Review of Western Sydney Airport Draft Environmental Impact Statement

26 November 2015

Document information
Client: WSROC Title: Review of Western Sydney Airport Draft Environmental Impact Statement Document No: 2269591A-ENV-REP-001 RevFINAL Date: 26 November 2015

Ground-based noise and vibration assessment peer review

Figure 1: Comparison of average daily airport movement numbers with other existing Australian International airports

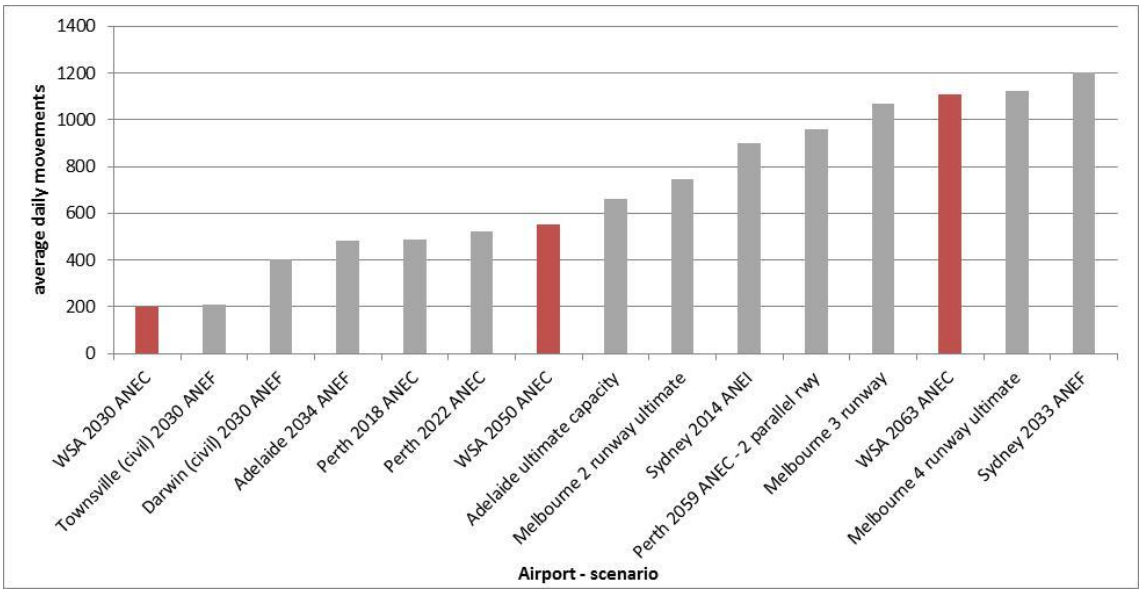
A general review of the movement numbers associated with Stage 1 development has been carried out by comparing the values with current and future movements at other Australian international airports. Figure 1 shows the proposed daily movement numbers for the Stage 1 development appear relatively low compared with other Australian international airports. This may be reasonable given the relatively short time period of 5 years between the commencement of operations and the assessment year. However, this directly translates to a relatively low numbers of aircraft events exceeding relevant noise thresholds when compared to the longer term development plans for the site. Given the objective of the proposal is to develop a major international airport, the relatively low movement numbers raises the question of the suitability of the 5 year time horizon as the appropriate primary assessment scenario for the purpose of obtaining approval for the development, irrespective of the incremental and periodic approvals (under the Airports Act) that would need to occur as part of the ongoing expansion of the airport.

These comments are provided primarily in relation to the plausibility of the movement numbers represented in the noise modelling, based on comparisons with the movement numbers documented in the noise modelling for other Australian international airports and similar time horizons. Aircraft traffic forecasts are however outside of our area of expertise and therefore the suitability of the specific movement numbers adopted for the stage 1 noise assessment are considered in further detail in a separate aviation peer review commissioned by WSP Parsons Brinckerhoff.

The movement numbers for the 2050 scenario are consistent with forecasts for similar single runway Australian International airports (Perth, Adelaide), refer Figure 1. Accordingly, the predicted noise levels for this scenario would appear more suitable as the appropriate primary assessment scenario for the purpose of obtaining approval for the development.

Figure 2: Extract from section 3 of the technical report illustrating the influence of mode 23 movements in the Prefer 05 operating scenario

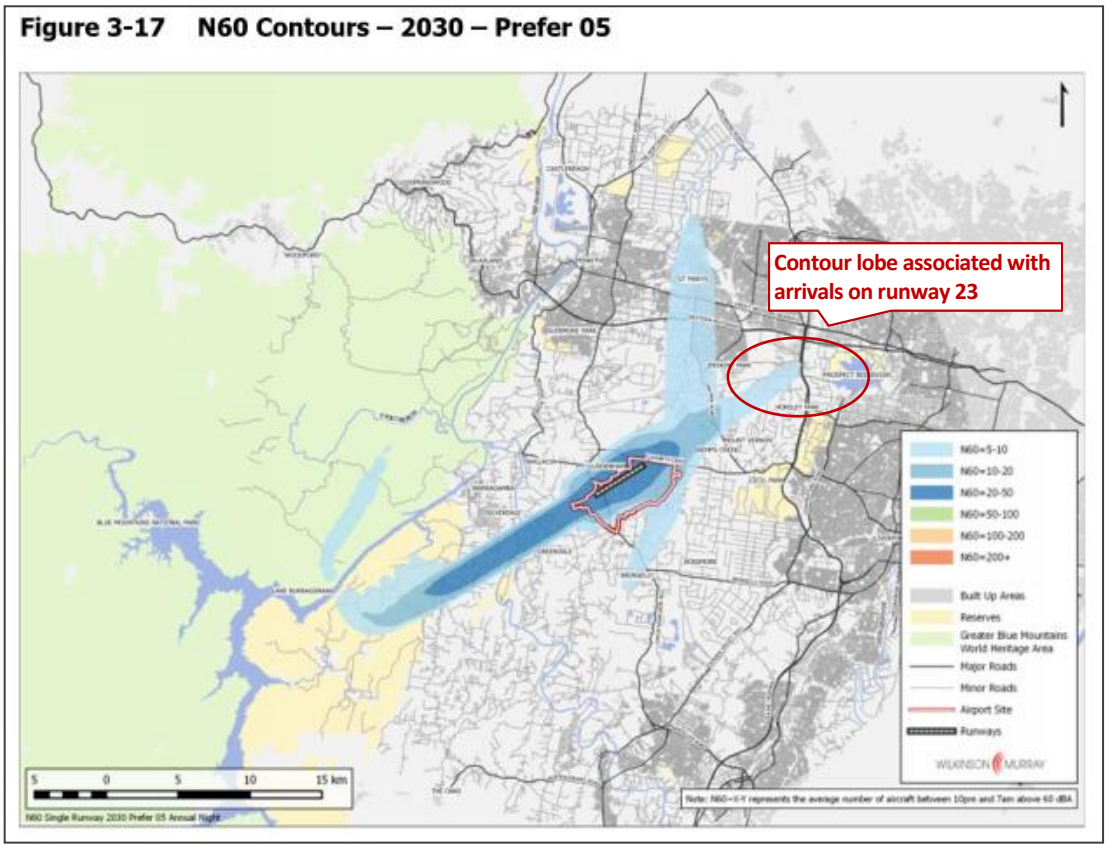
- Noise contour information is presented in terms of ANEC data and NA values for alternative operating configurations including preferred operating strategies such as Prefer 05 (runway strategy favouring movements directed from the southwest and toward the northeast) and Prefer 23 (runway strategy favouring movements directed from the northeast and toward the southwest). It is evident from the noise contours that the Prefer 05 and Prefer 23 scenarios include movements occurring in both directions. For example, this is most evident on figures for scenario Prefer 05. These figures illustrate contour lobes extending to the northeast along the runway centre line, beyond the extent of the departure track, thus indicating the influence of an arrival movement on runway 23 (see example extract in Figure 2 below). Technically this is consistent with the definitions provided for Prefer 05 and Prefer 23. However, these contours may be prone to misinterpretation as single mode contours which illustrate the noise associated with movements occurring in single directions (and would extend further than the illustrated Prefer 05 and Prefer 23 strategy noise contours).

Figure 2-1 – Noise monitoring locations which are closest to the Site boundary

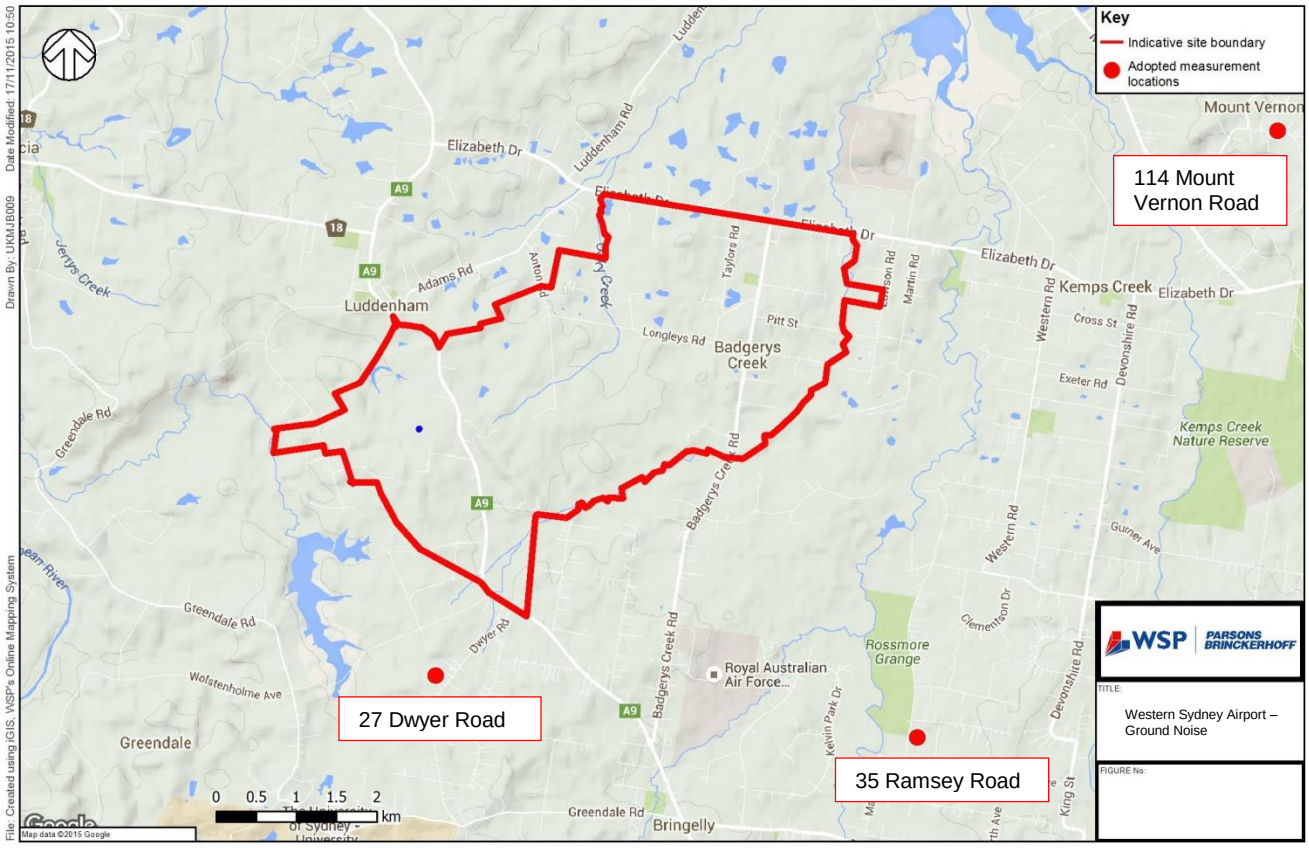
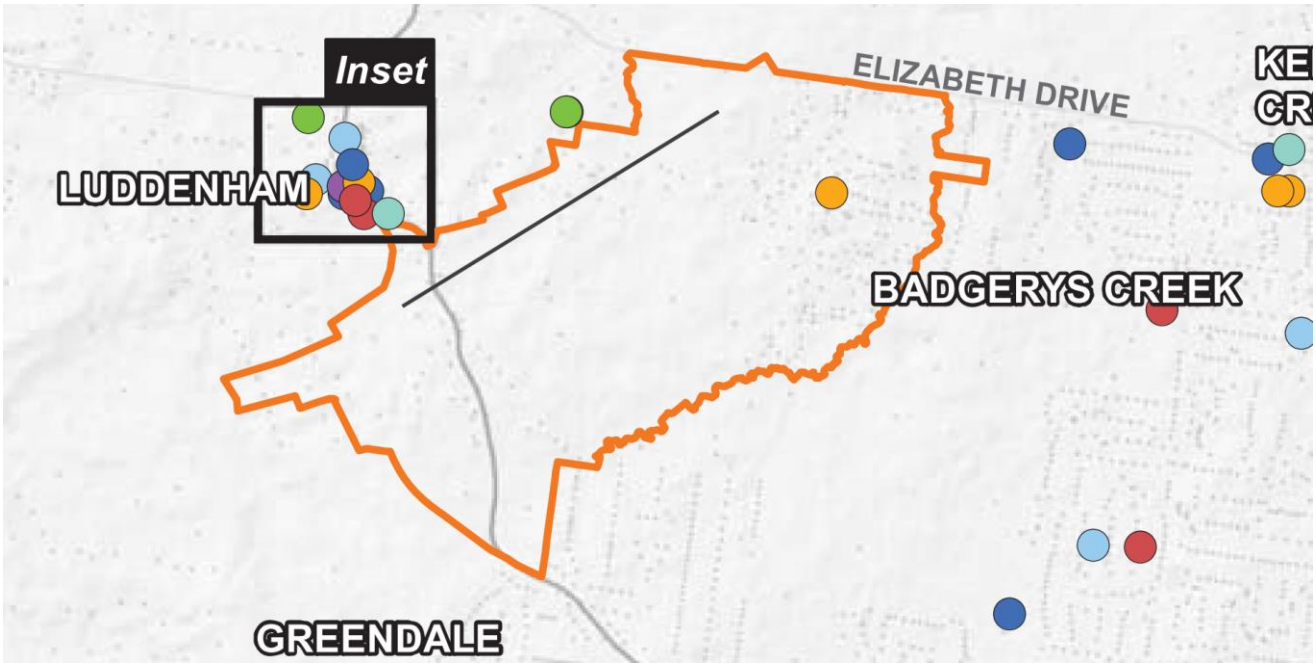
From a review of available aerial mapping, there are closer noise sensitive receptors in the area than those selected for noise monitoring, leaving uncertainty over the noise impacts on the most affected noise sensitive receptors, particularly for properties in Luddenham to the north west of the Site. Figure 2-1 shows the adopted noise monitoring locations that are closest to the Site boundary. Figure 2-2 shows that there are many noise sensitive receptors much nearer to the Site boundary (marked in grey). Further consideration should therefore be given to quantifying the existing noise environment for properties closest to the airport.

There is insufficient detail provided to accurately determine the specific noise monitoring locations, whether noise measurements were taken in free-field conditions, or at what height above ground microphones were positioned at. It is not possible to determine whether microphones had direct line of sight to dominant noise

sources such as main roads, or whether they were placed in backyards. There is a risk that existing noise levels have been overestimated if they have not been placed on quietest facades of residential receptors. The existing noise levels have been used to determine assessment criteria, so this information could potentially affect the conclusions of the assessment. Therefore the precise measurement locations should be defined.

Figure 2-3 - Sensitive receivers surrounding the airport site (reproduced from Western Sydney Airport draft EIS)

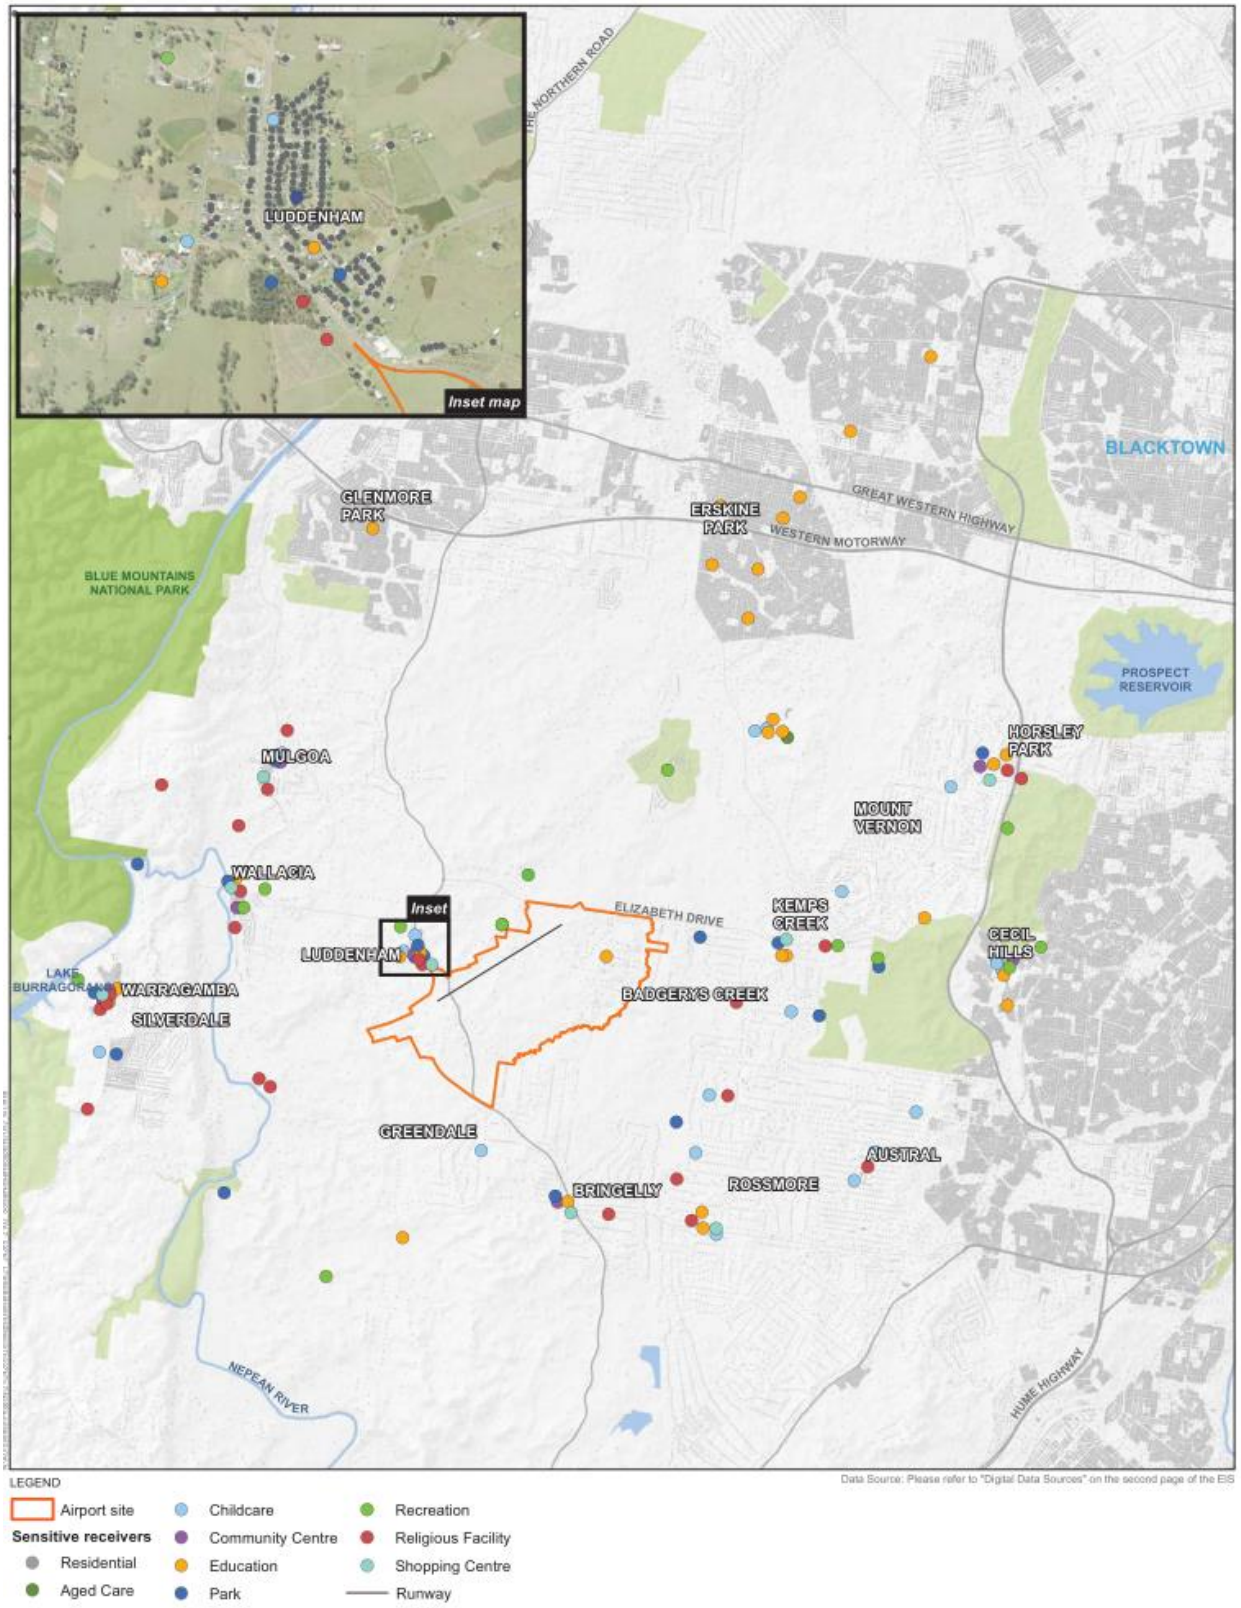
Figure 11-2 (reproduced below in Figure 2-3) depicts the noise sensitive receptors surrounding the airport site. It identifies the location of nearby non-residential noise sensitive receptors in the area clearly, however the location of residential receptors is indicated by very small points in light grey, which are difficult to observe and could be considered misleading. It is recommended that Figure 11-2 is updated to show more clearly the location of residential receptors.

Section / Paragraph Reference	Text Reference / Figure Description	Comment	Recommendation	Significance of Issue
11.3, Figure 11-2, p79	A figure depicting noise sensitive receptors surrounding the airport site	It is difficult to see the location of nearest residential receptors, as their location appears to be indicated by very small points in light grey – whereas the other types of receptor are more clearly marked. It is also difficult to see this in the inset image displaying Luddenham. The initial impression that the figure currently gives is that there are little, if any.	Recommend that the figure is updated to show more clearly the location of residential receptors, particularly in Luddenham.	Noted for information.

Figure 2-4 - Ground based operational noise source locations, 2030 (reproduced from EIS Appendix E2 Figure 3-1)

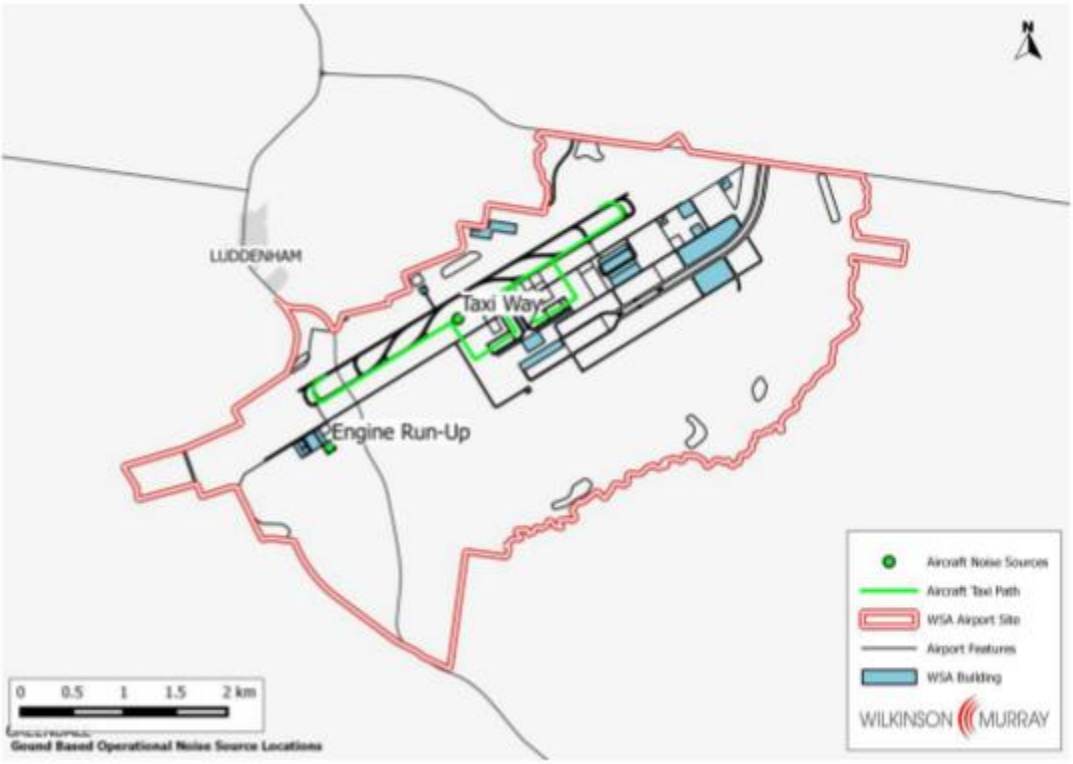
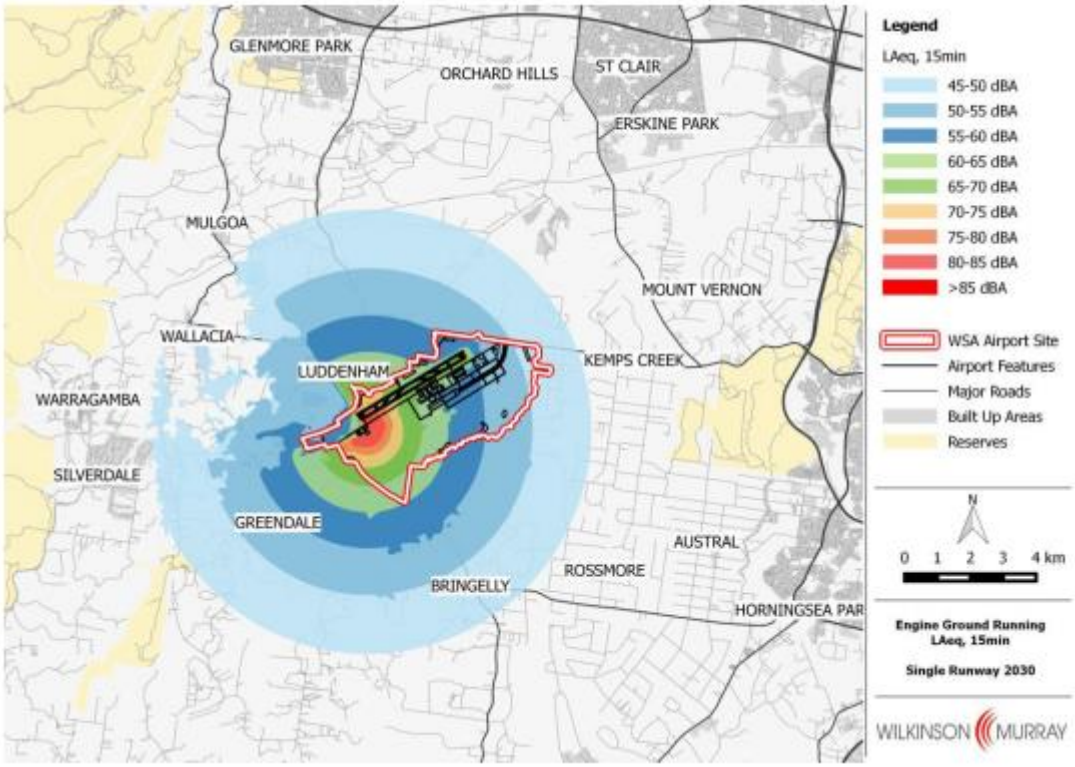
The assumed location for ground run-ups is defined in Figure 3-1 of Appendix E2 (presented in Figure 2-4 below), however the indicative building location near the location is not finalised nor is fixed within the application. Figure 3-2 of Appendix E2 (presented in Figure 2-5 below) shows that communities to the west and north west of the Site benefit from the screening afforded by this building. Noise impacts could significantly change if the buildings or run-up area change location. It is therefore considered appropriate to assess a scenario where the building does not provide any acoustic benefit, to take into account that final locations are not fixed and may change.

Section / Paragraph Reference	Text Reference / Figure Description	Comment	Recommendation	Significance of Issue
3.5.1 / p13, para 2, Figure 3-1, Figure 3-2	*"It has been assumed that aircraft ground runs would occur at the location shown in Figure 3-1."*	It is acknowledged that the assumed location for run-ups is defined in Figure 3-1, however there is a concern that, at this stage, the indicative building location near the position is not finalised nor is fixed within the planning application. It is evident from Figure 3-2 that communities to the west and north west of the Site benefit from the screening afforded by this building. Should the building or run-up area move, it is likely that it could significantly affect the resulting noise impact from the Site.	Given the indicative layout, and the level of assumed acoustic benefit provided, it is considered appropriate to assess a scenario where the building does not provide any acoustic benefit, to take into account that final locations are not fixed and may change.	High

Figure 3-1 - Ground-based operational noise source locations, 2063 (reproduced from Appendix E2 Figure 3-4)

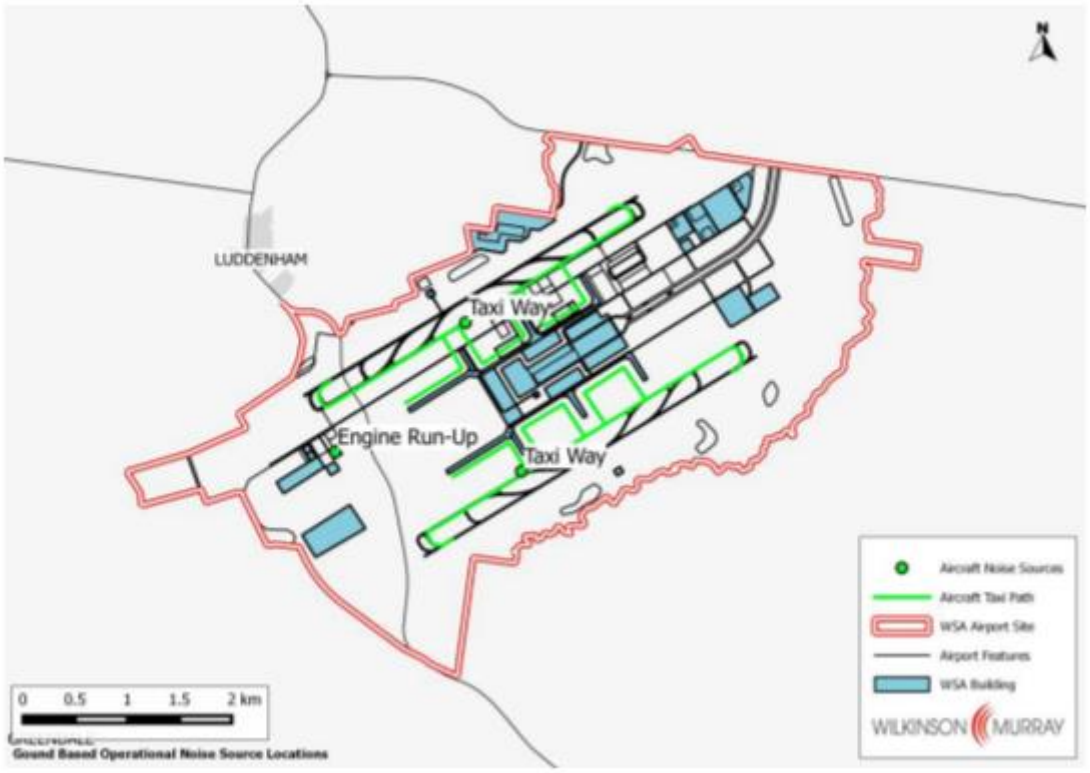
Engine ground run-up noise in 2063 has been modelled at the location indicated in Figure 3-4 of Appendix E2, shown below in Figure 3-1. Figure 3-5 of Appendix E2 shows the noise propagation from this source but does not have the same level of acoustic screening afforded by nearby buildings as that shown in Figure 3-2 of Appendix E2, which is the corresponding noise contour plot for the single runway scenario. These two figures are compared in Figure 3-2 below). There is therefore uncertainty regarding the level of screening from buildings.

Clarification is also required regarding the assumption that, in the event of a two runway airport, there would continue to only be one ground run-up area.

3.7 / p17, para 2, Figure 3-4, Figure 3-5	*"Ground-based noise levels have been predicted for the longer term airport development using the same methods as for the initial airport development. The noise source locations are shown in Figure 3-4 and the resulting contours are shown in Figure 3-5 and Figure 3-6."*	The text infers that, even with two runways and a significant increase in aircraft movements as a result, there would still be only one engine run-up for less than 5 minutes in any 15 minute period. This single point source of noise has been modelled as indicated in Figure 3-4, however Figure 3-5 (which shows the noise propagation) does not appear to have the same level of acoustic screening from nearby buildings as the similar situation in Figure 3-2, which suggests that either Figure 3-2 overestimates the level of acoustic screened afforded by buildings, or Figure 3-5 underestimates this.	Clarification that, in the event of a two runway airport, there would continue to only be one ground run-up area. Confirmation that the acoustic screening from buildings has been correctly accounted for in both Figure 3-2 and Figure 3-5	Medium
